Subject: AP1000 Response to Request for Additional Information (SRP 6)

RAI-SRP6.2.2-SRSB-25 R1

AP1000 TECHNICAL REPORT REVIEW

RAI Response Number: RAI-SRP6.2.2-SRSB-25
Revision: 1

Figure 1: Containment Pressure with and without Fan Coolers in Operation

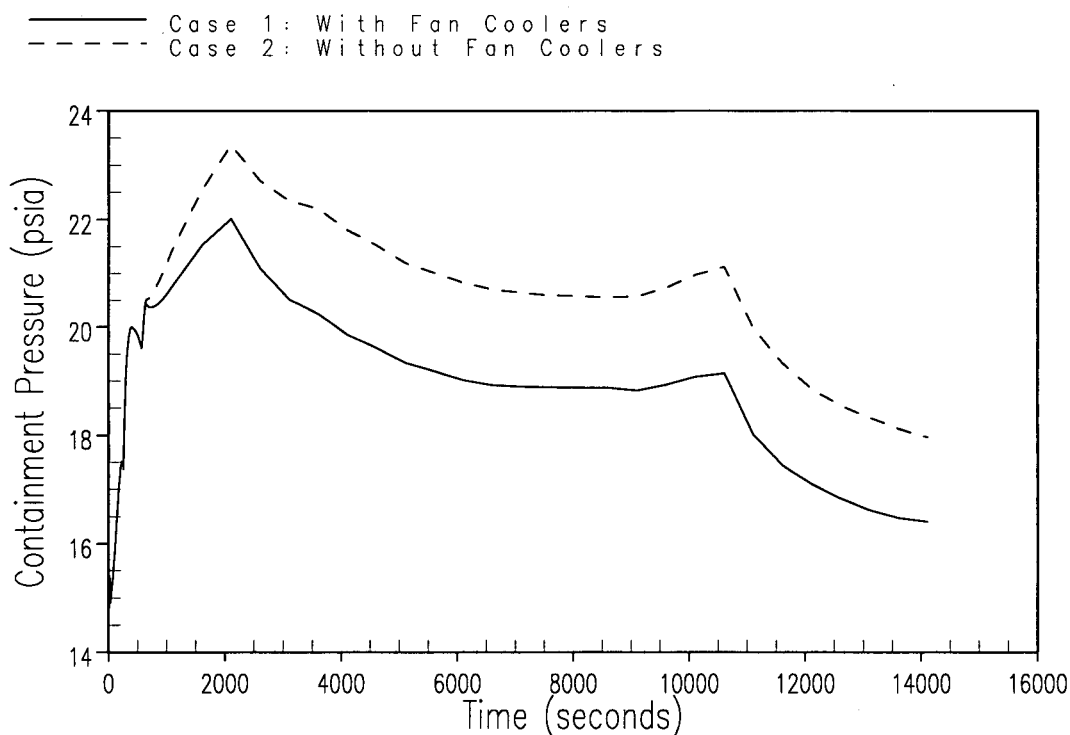
- b. The WGOthic calculation of the containment conditions was performed based on the assumption of the fan coolers in operation, which resulted in the lower containment pressure, as well as lower sump water temperature. While lower containment pressure is conservative for the long-term cooling analysis, lower sump water temperature may be non-conservative. Provide an evaluation to demonstrate the assumption of the fan coolers in operation is limiting for the long-term cooling analysis.

- b. APP-SSAR-GSC-682 Rev. 1 discusses the effects on temperature and pressure associated with the containment response with and without fan coolers in operation. From Figure 1 (taken from APP-SSAR-GSC-682 Rev. 1) the differences in containment pressure are displayed. The case with fan coolers in operation clearly depicts a lower containment pressure which has already been established as conservative for the LTCC analyses.
